September 14, 2023

**Re: Division's Second Response to Inspection Report Problem Submissions for the Pueblo County Aggregate Project (PCAP), M-2016-009**

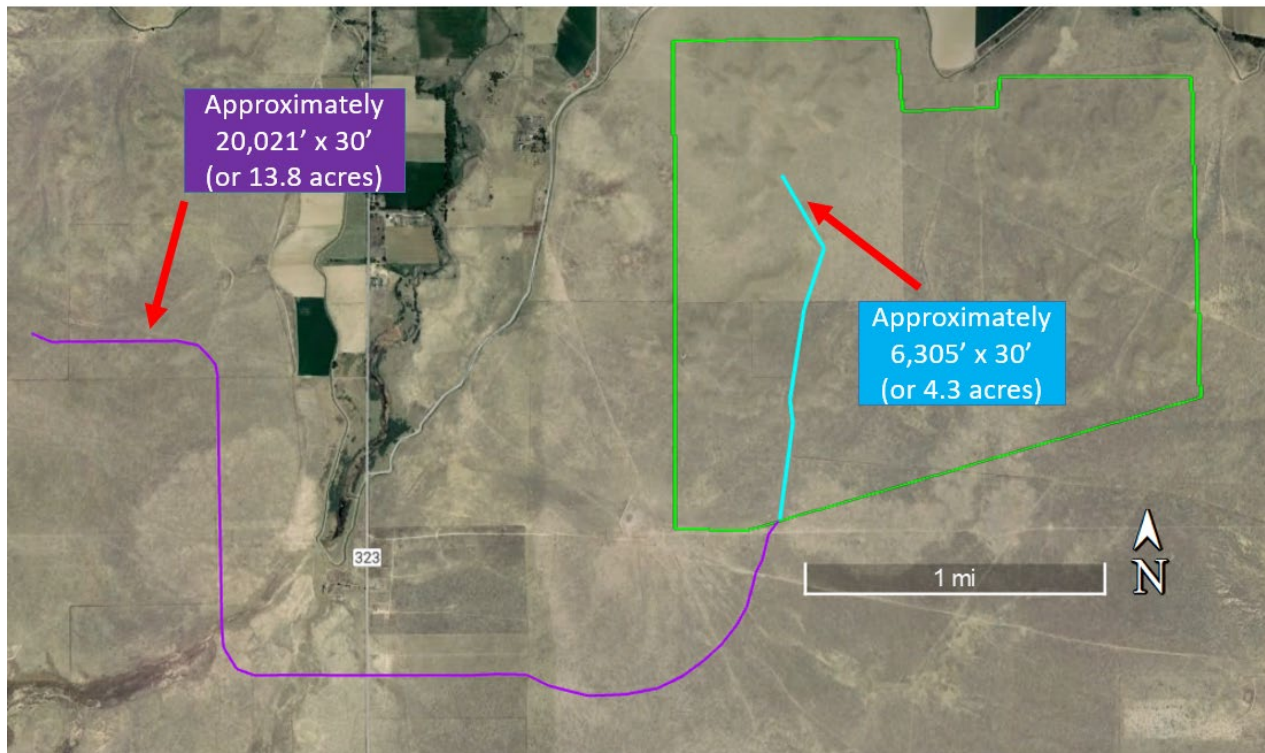
- "As for the bond, Fremont would like to submit a Technical Revision and Surety Reduction request and will commit to keeping the active mine area to 15 acres, plus 14 acres for the haul road. It is Fremont's understanding, as described in the first response to this inspection that 15 acres will be actively mined following the reclamation of the previous 15 acres. However, full vegetation need not be accomplished prior to moving to the next 15 acres."

- The Division's preliminary cost estimates provided in the previous response letter dated September 8, 2023 estimated reclamation responsibility for 15 acres of active mining, haul road acreages, and 25% of the currently affected but un-released reclaimed land. Until this land is released either through final bond release, an acreage reduction, or a surety reduction, the Division must hold a bond for this area to cover liability for at least some reseeding and weed control.
  - To clarify, the Division estimates the haul road acreages for the South Haul road and the Phase 1 internal haul road to equate to approximately 18.1 acres for the duration of mining in Phase 1 (see below).

- The Division will not issue a surety increase at this time due to the Operator's intentions to submit a Technical Revision to revise the mine plan. The Operator shall submit the Technical Revision to the mine plan by **October 8, 2023**.
